NORTHERN BEACHES COUNCIL ASSESSMENT REPORT

Panel Reference	PPSSNH-199
DA Number	MOD2021/0041
LGA	Northern Beaches Council
Proposed Development	Modification of Development Consent DA2018/1574 granted for construction of a mixed development comprising three residential flat buildings, commercial use of a heritage listed building, car parking, infrastructure and landscaping
Street Address	Lot 11 DP 577062, 23 Fisher Road, Dee Why
Applicant/Owner	Salvation Army (NSW) Property Trust Hamptons By Rose Pty Ltd
Date of DA lodgement	14 March 2021
Number of Submissions	Two (2) submissions
Recommendation	Refusal
Regional Development Criteria (Schedule 7 of the SEPP (State and Regional Development) 2011	Section 4.55(2) Modification of the Development Consent granted by the Sydney North Planning Panel (SNPP) which has a variation to a Development Standard exceeding 10%
List of all relevant s4.15(1)(a) matters	<ul style="list-style-type: none"> • Environmental Planning and Assessment Act 1979 • Environmental Planning and Assessment Regulation 2000 • State Environmental Planning Policy No. 55 - Remediation of Land • State Environmental Planning Policy (Building Sustainability Index: BASIX) • Stat

Figure 2 - Approved Development – 13m height plane overlay

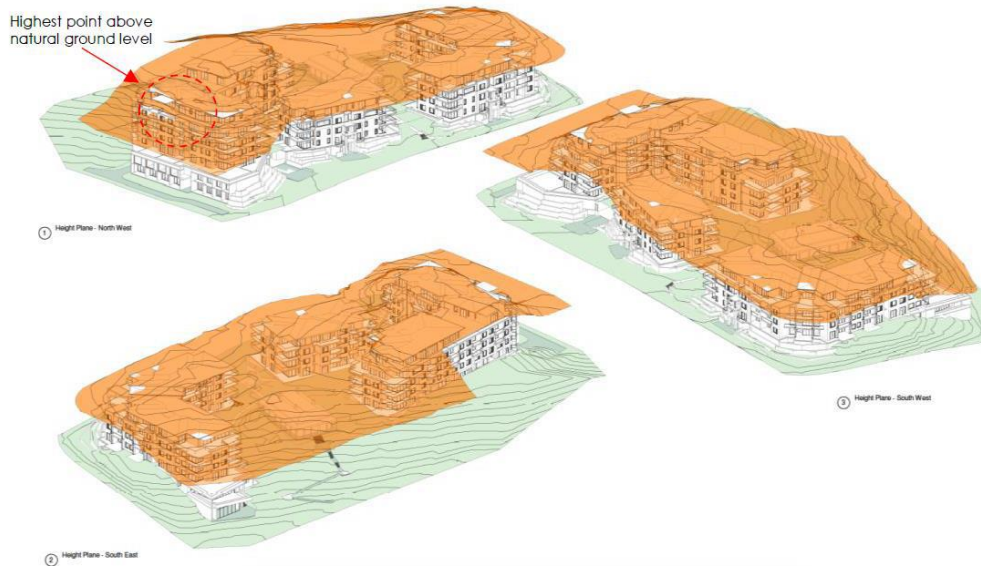
The approved development was subject to Clause 4.6 in relation to building height, which was calculated at 2.9m above the 13m height standard (22.3% exceedance). However, no full levels were outside of the height plane as demonstrated in the diagram below:

Figure 3: Modified Development Height Plant Diagram.

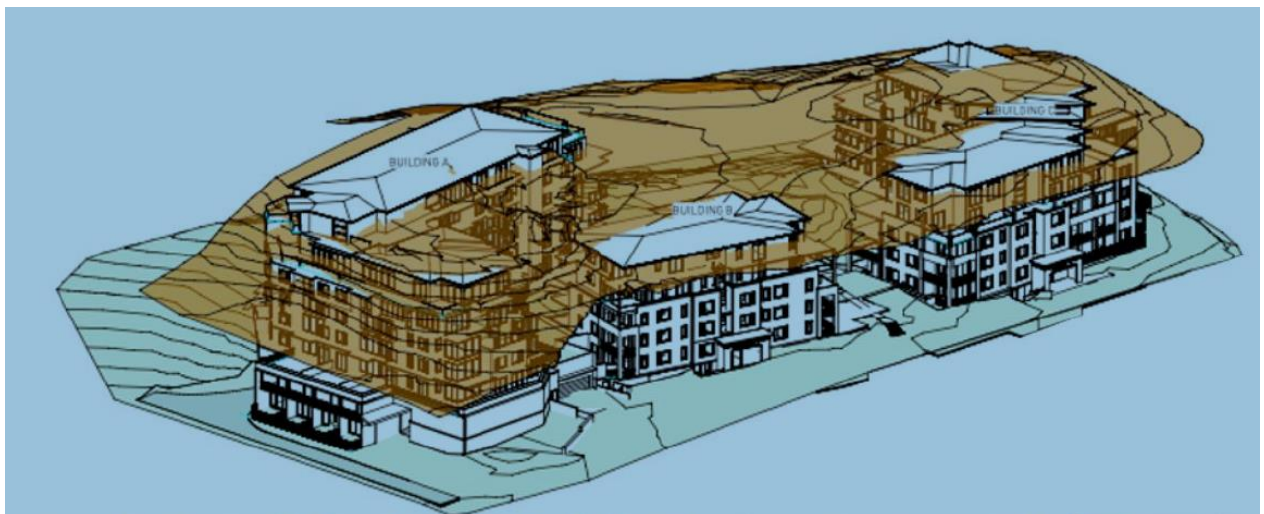
The proposed modifications will result in a maximum height of RL+57.38m (ridge of Building A), resulting in a maximum 2.35m over the 13m height control (or 18% variation). Building B and C exceed the height control (at their maximum ridge line) by 1.60m to 1.95m.

The modification seeks to increase the building height to a maximum height of RL+57.38m (ridge of Building A), resulting in a maximum 2.35m over the 13m height control (18% variation). Building B and C exceed the height control (at their maximum ridge line) by 1.60m to 1.95m. (Note: the current approved building already exceeds the maximum height but the volume of building exceeding the height is substantially less).
